Planning Report

Bridge Park East Section 4 (Block G) – Final Plat

Agenda Item	3
Case Number	16-044FP
Site Location	Southwest corner of Tuller Ridge Drive and Dale Drive.
Proposal	The creation of an approximately 2.28-acre lot (Lot 9) and associated access easement for open space for a mixed-use development, including two buildings containing residential dwelling units, commercial uses and a parking structure.
Request	Review and recommendation of approval to City Council for a Preliminary and Final Plat in accordance with the Subdivision Regulations (Chapter 152 of the Dublin Code of Ordinances).
Owner/Applicant	Crawford Hoying Development Partners.
Case Manager	Claudia D. Husak, AICP, Senior Planner
Contact Information	614-410-4675 chusak@dublin.oh.us
Planning Recommendation	<u>Approval of the Final Plat with 1 Condition</u> This proposal complies with the plat review criteria and approval of this request is recommended with one condition. 1) That the applicant ensures that any minor technical adjustments to the plat are made prior to City Council submittal.

Site Overview

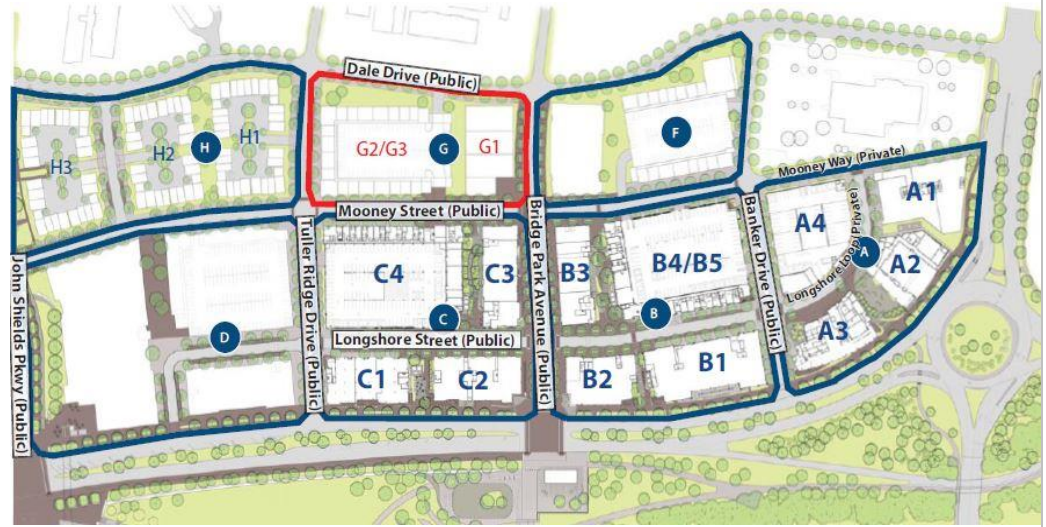
Criterion met with condition: This proposal is consistent with the requirements of the Subdivision Regulations and Zoning Code. Any other minor technical adjustments should be made prior to Council review.

Analysis	Final Plat
<i>4) Open Space Requirements</i>	Criterion met with waiver: Code requires 0.84-acre of open space dedication. This plat includes the 0.234-acre access easement for open space purposes. During the basic and final site plan reviews, the applicant I proposing to count the Scioto Riverside Park as part of the dedication requirement. A waiver has been requested to increase the distance an open space can be located from a primary entrance.

Recommendation	Final Plat
Summary	This proposal complies with the final plat review criteria and approval of this request is recommended with one condition.
Condition	1) That the applicant ensures that any minor technical adjustments to the plat are made prior to City Council submittal.
